METROPOLITAN GOVERNMENT OF NASHVILLE AND DAVIDSON COUNTY

STAFF RECOMMENDATION
2002-2002 1/2 Eastland Avenue
October 15, 2014

Application: Demolition; New construction-infill
District: Eastwood Neighborhood Conservation Zoning Overlay
Council District: 06
Map and Parcel Number: 08306038400
Applicant: John Root, architect
Project Lead: Sean Alexander, sean.alexander@nashville.gov

ARCHITECTURAL SITE PLAN

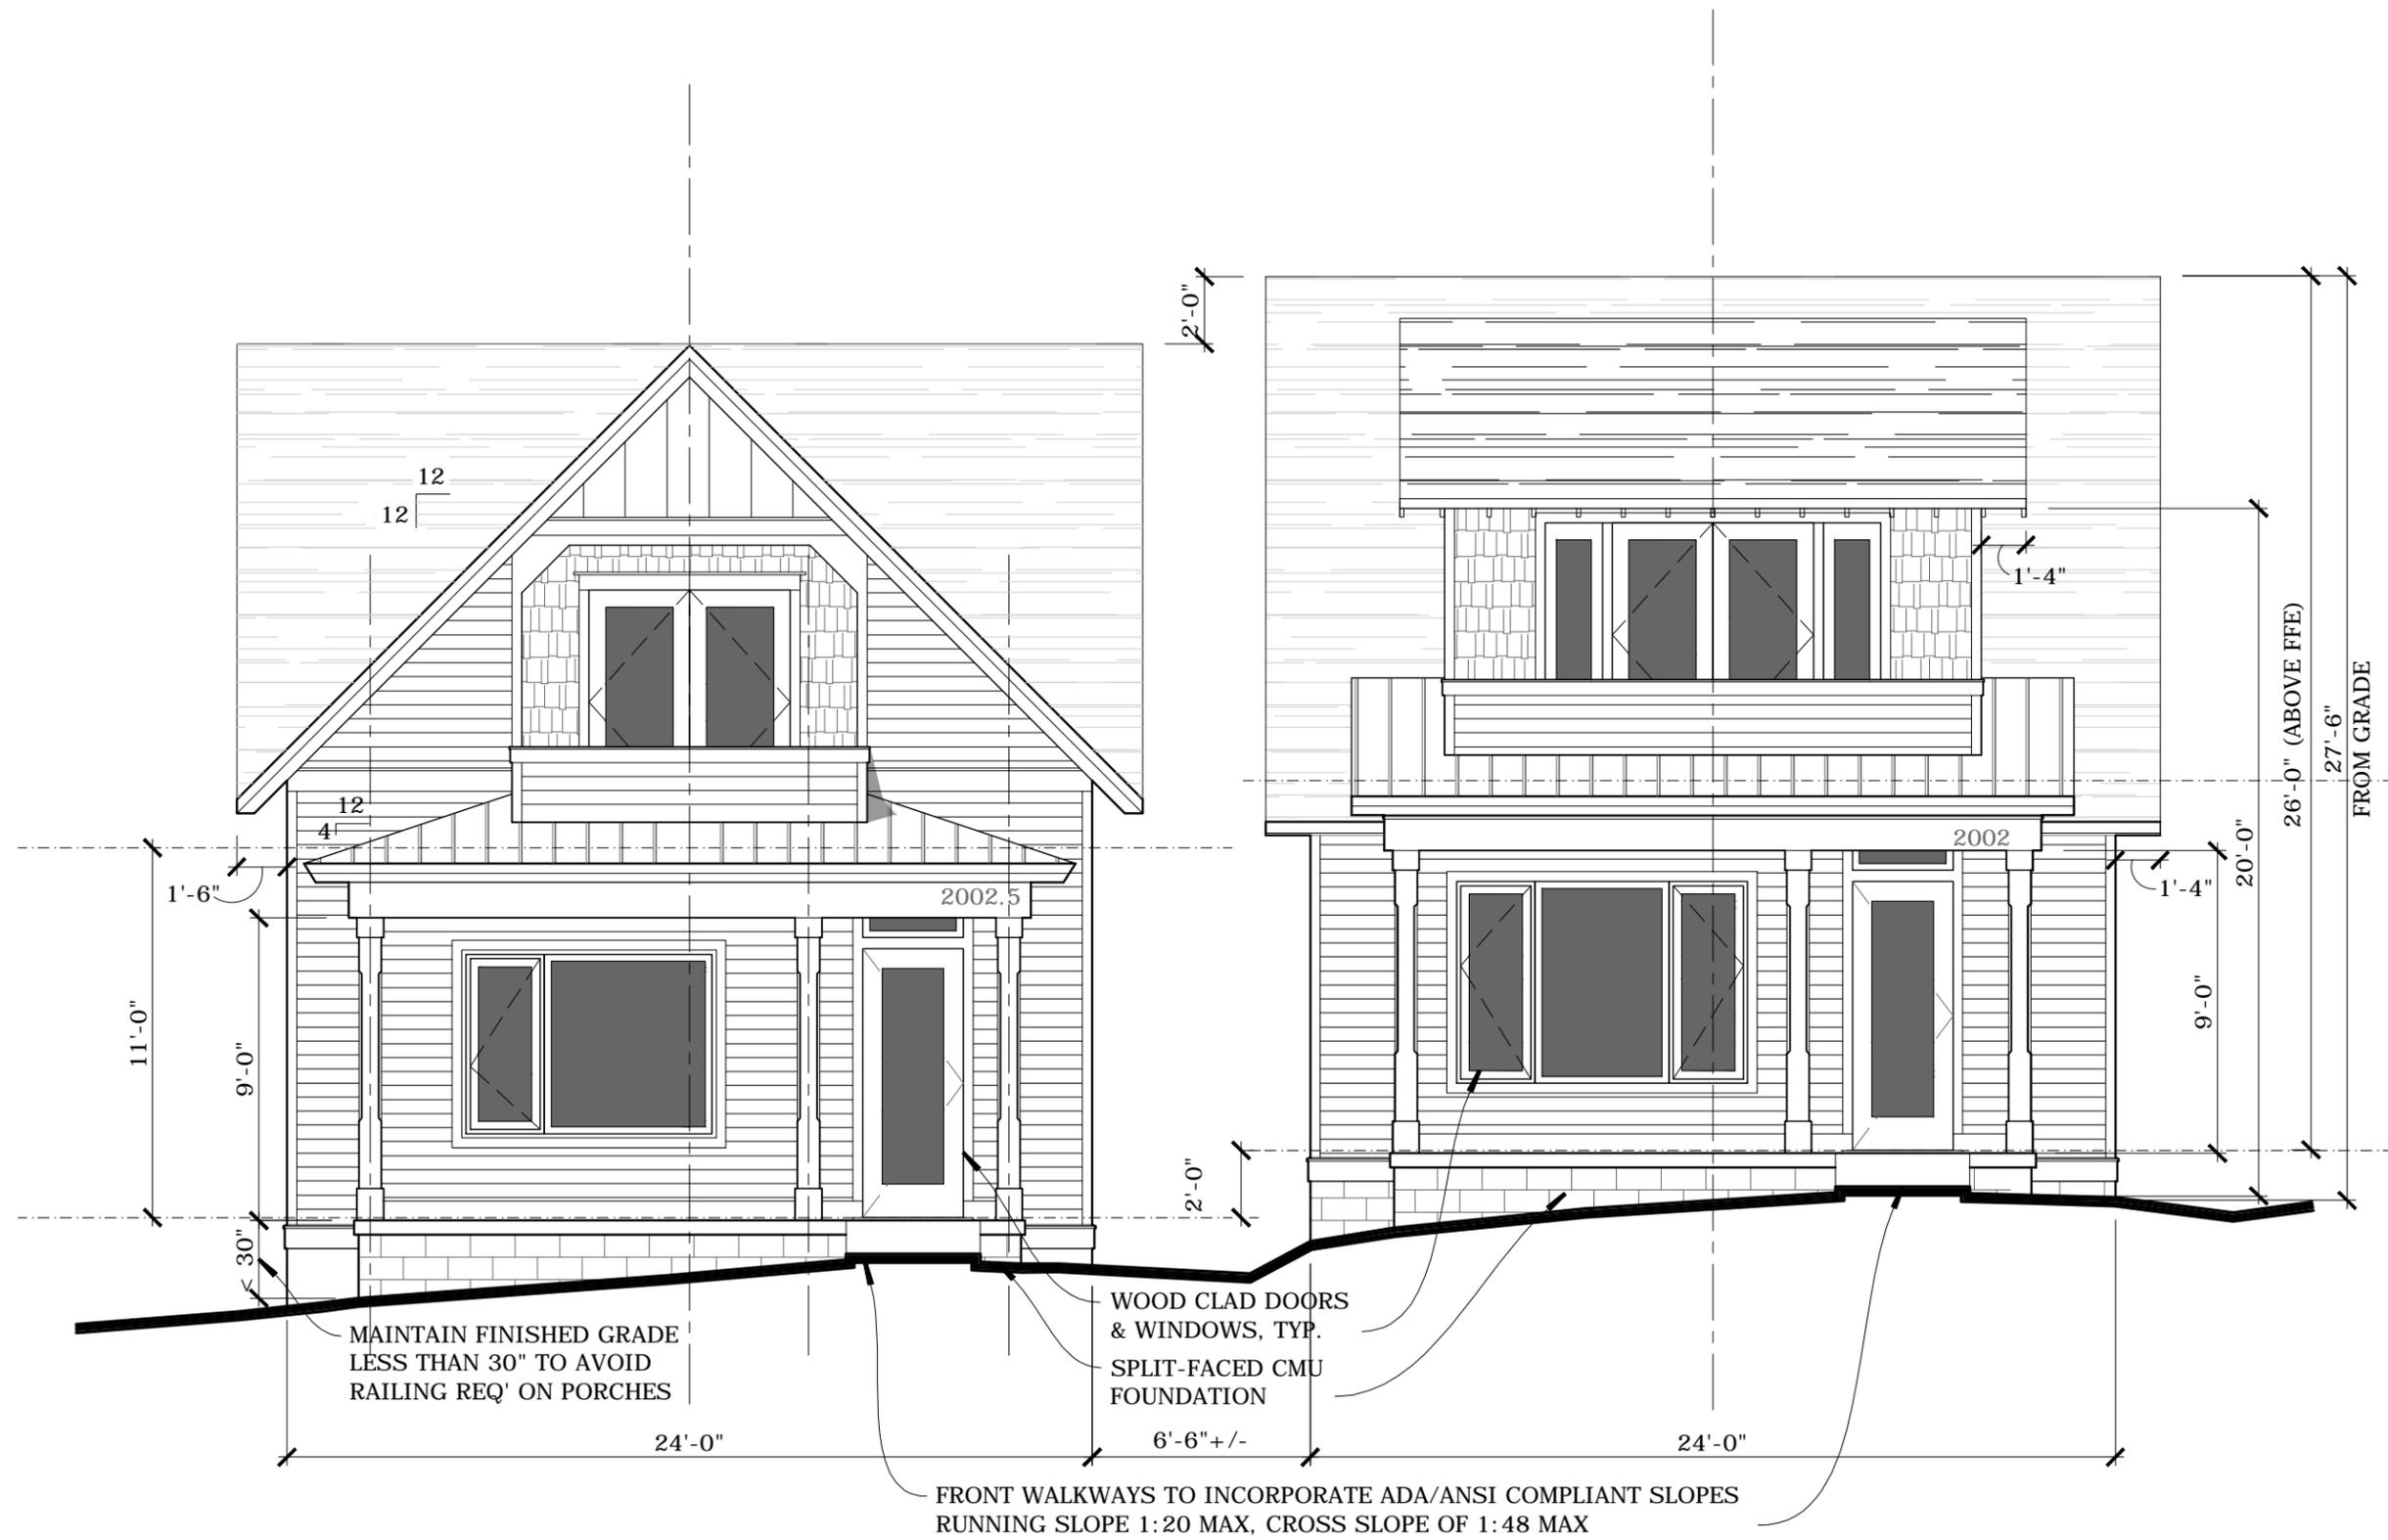
The new buildings will have front setbacks matching the two adjacent structures, both of which are contributing. The new buildings will have side setbacks of three feet (3'), with six feet (6') of space between them. Staff finds that these side setbacks, to the extent possible given the size of the lot, are the best solution for maintaining the rhythm of spacing between existing buildings on the street. The side setbacks also meet the MUN-A bulk zoning regulations. Staff finds these setbacks to be appropriate and to meet section II.B.1.c.

The location and orientation of the proposed new buildings will be similar to the adjacent historic houses with a front-facing, six foot (6') deep front porch and a walkway from the porch to the street. Both buildings will have paved parking areas at the rear, accessed from an alley. Staff finds that the project meets section II.B.1.f.

No changes to the site's appurtenances were indicated on the drawings, other than the paving and parking previously described. No exterior lighting or signage was proposed. The location of the HVAC will be at the rear of the buildings, which is an appropriate location. The project meets section II.B.1.i.

FRONT ELEVATIONS

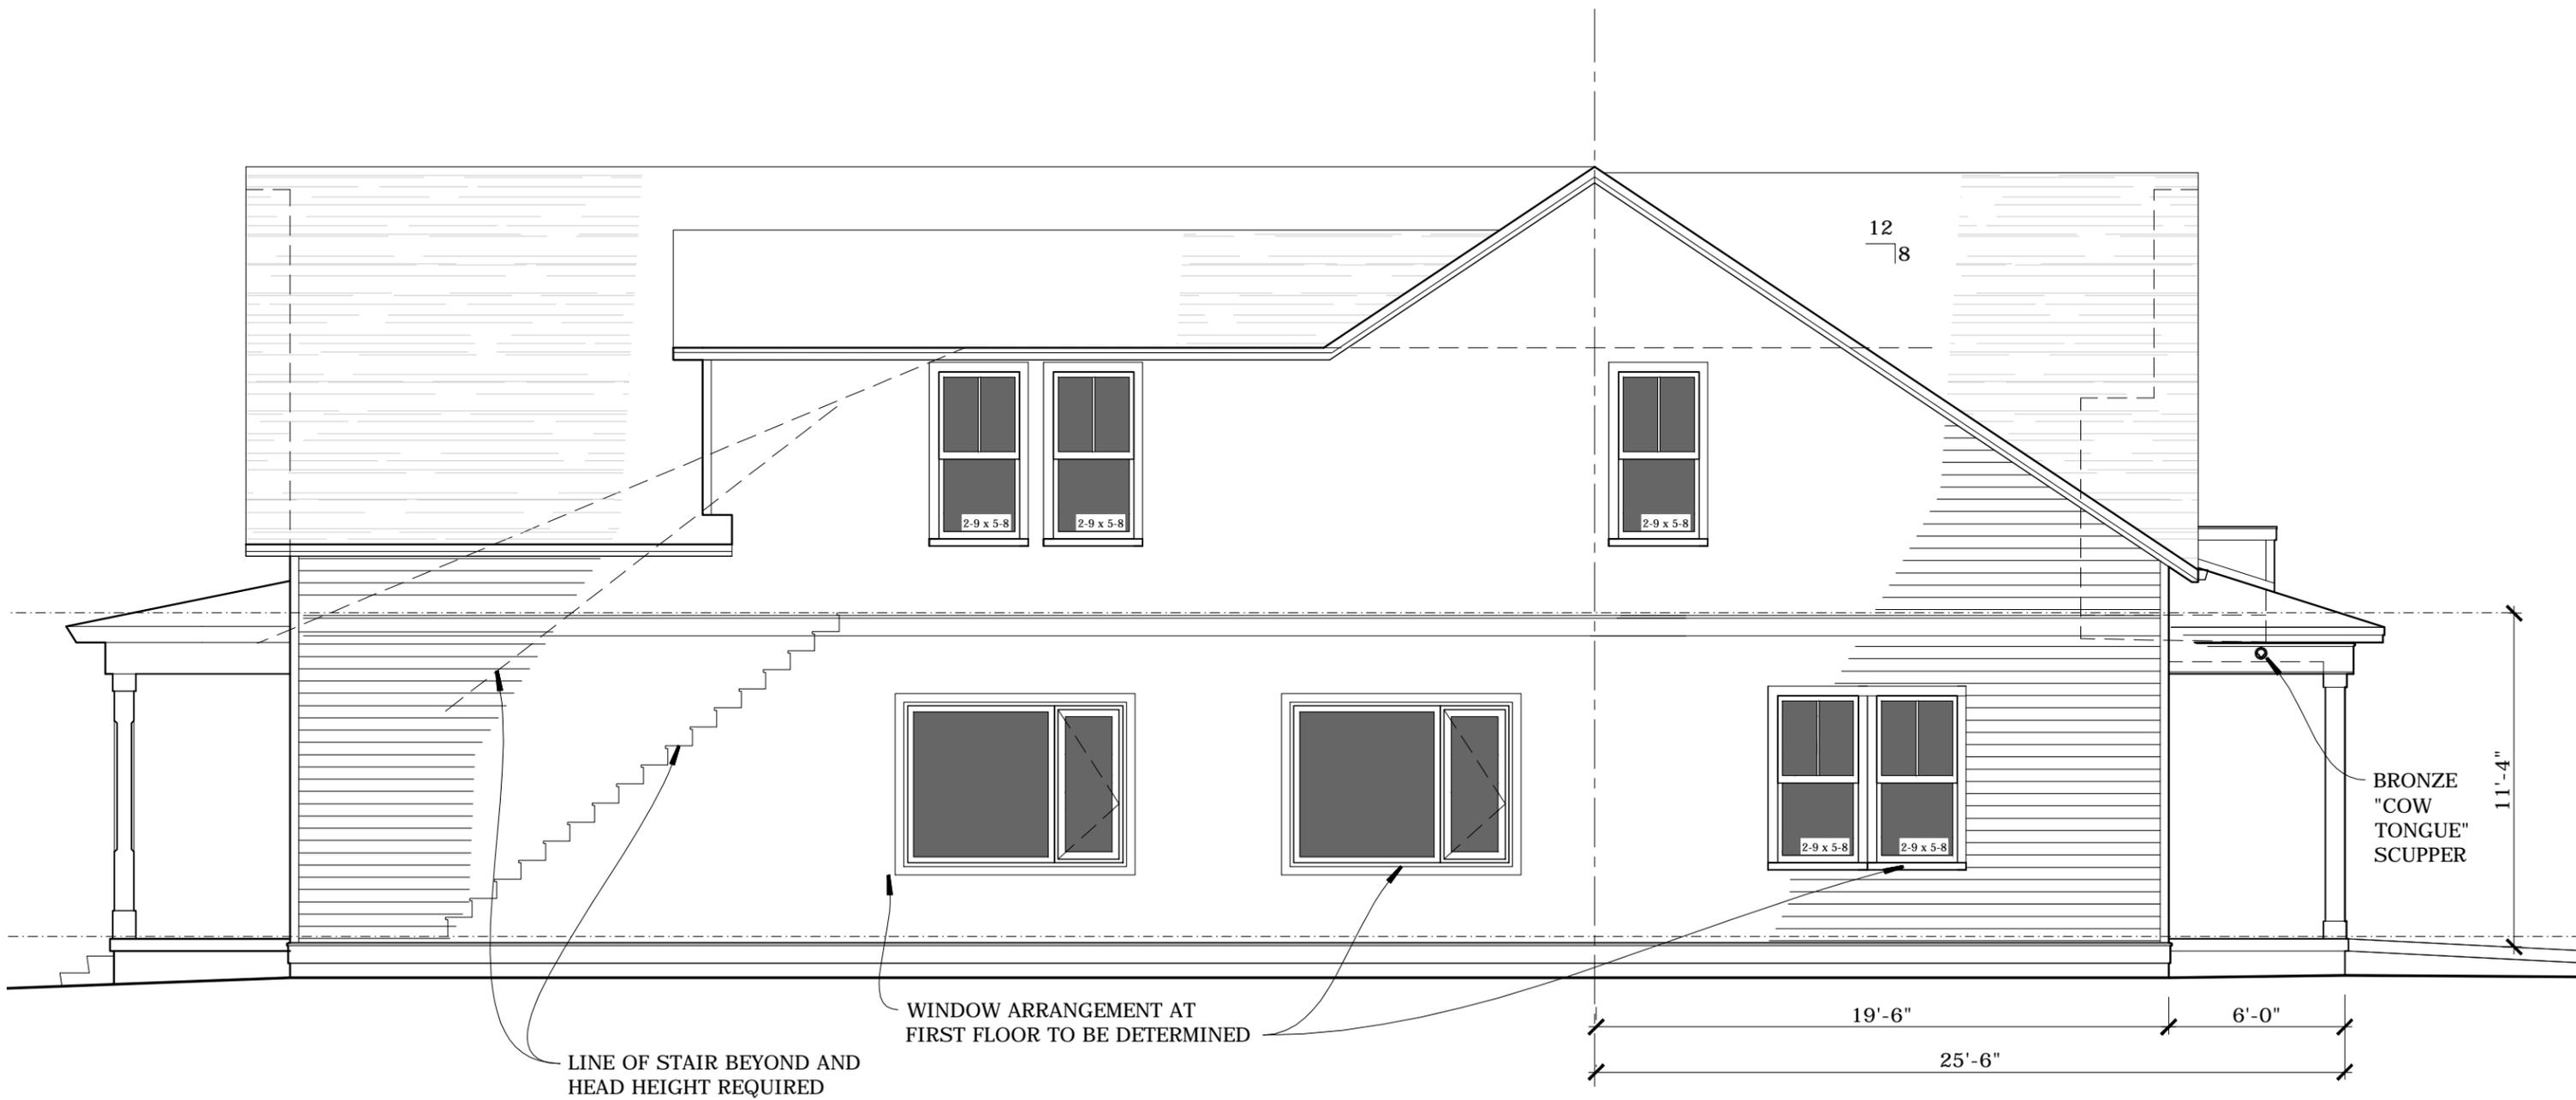
In the revised plans, the roofs of the buildings have been revised to be more like those of historic houses in the surrounding area. The building on the left will have a cross-gabled roof, with a pitch 8:12 on slopes of the side gables and a 12:12 pitch on the front and rear gables. The building on the right will have a similar roof, with a 3:12 pitched shed dormer instead of a front-projecting gable. Staff finds these roofs to be compatible with the roofs of historic houses nearby in pitch and form, and to meet guideline II.B.1.e.

The widths of both buildings will be twenty four feet (24'), which is as wide as Codes would allow on a thirty-foot (30') wide lot. In lowering the roof pitches, the heights of the buildings will be lowered to twenty-six feet (26') tall from the floor level to the roof peak. The eave heights will be twelve feet (12') above floor level for the building on the left and nine feet, six inches (9'-6") for the building on the right. Following grade that drops to the left (East), the foundations will vary from eighteen inches (18") to thirty inches (18") tall.

The front windows on the first story of the building will be commercial-type casements or fixed windows, and the upperstory windows and the side elevations will also have these windows, as well as side double-hung sash windows. The front windows are modern interpretations of a front "picture" window with two side-lights seen on some buildings as early as the 1930s and 1940. Although not generally appropriate for side elevations, the fixed and casement-type windows on these buildings will be at the rear and will not be greatly visible. Staff finds the project's proportion and rhythm of openings would meet Section II.B.1.g.

1. The finished floor height shall be consistent with the finished floor heights of the adjacent historic houses, to be verified by MHZC staff in the field;
2. Staff approve the roof colors and the final details, dimensions and materials windows and doors prior to purchase and installation;
3. Staff approve the materials of the porch floor and front steps;
